Access Compliance Report

Public Rights-of-Way

Intersection ID: 49295	Main Street: CREEKSIDE_PARK_RD	Cross Street: ROYAL_WINCHESTER_DR	Location: N
ADA ID: F22F4CE9F921	Ramp Type: BlendTrans1	Initial Pass/Fail: Pass	Overall Compliance: No
Severity Score: 0.25			
Codes/Mitigation Info/Possible Solution		Field Measurements/Component Compliance

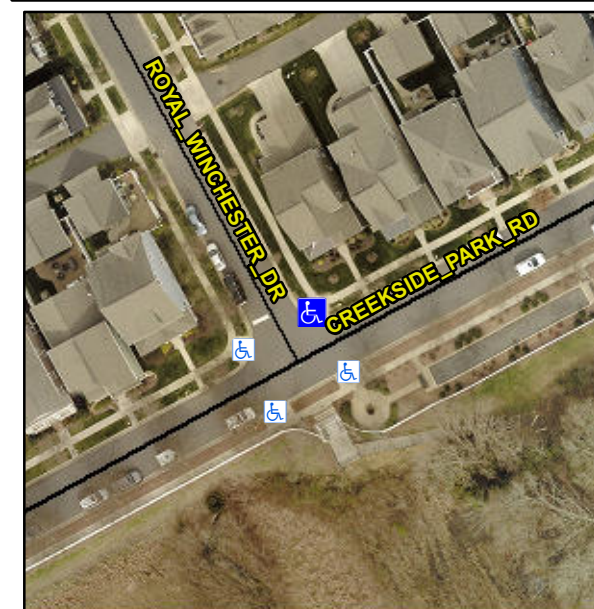
Remove & Replace Curb Ramp With Two New Directional Ramps or Equivalent. Remove & Replace Gutter.

Not Found, R304.5.3, R304.2.1, R304.2.2-Perp, R304.3.2-Para, R305.2
